# 1989 - 1991 Corvette: Service Bulletin: No/Delayed Reverse When Cold

**Subject:** NO/DELAYED REVERSE WHEN COLD INSTALL REV.  
INPUT CLUTCH SEAL

**Bulletin Number:** 91-493-7A - (03/11/1992)

**SUBJECT: ----- No Reverse/Delayed Reverse Cold (Install Long Lipped Reverse Input Clutch Piston Outer Seal)**

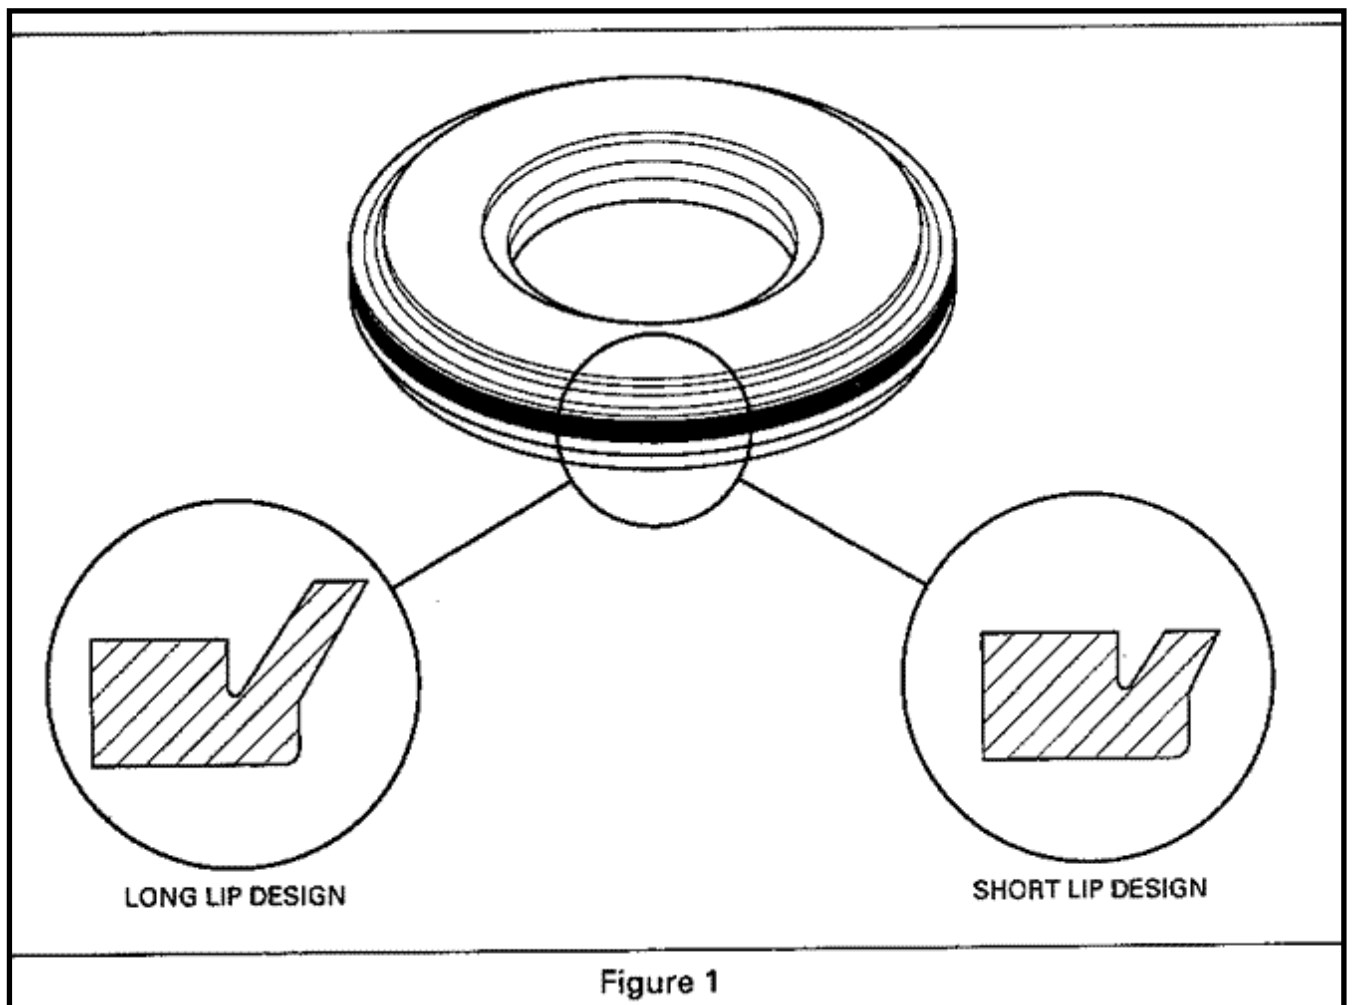
If a transmission has a 'no reverse' or 'delayed reverse' condition, inspect the reverse input clutch piston outer seal. Determine if the seal is a 'short lip' or 'long lip' design by comparing it to Figure 1. If it is a short lip design, replace it with a long lip seal contained in the service packages listed under Service Parts Information.

If the reverse input clutch piston outer seal is a long lip design, or the newly installed long lip seal doesn't alleviate the delayed reverse condition, the reverse input clutch housing may be out of round. Inspect the housing and replace if necessary.
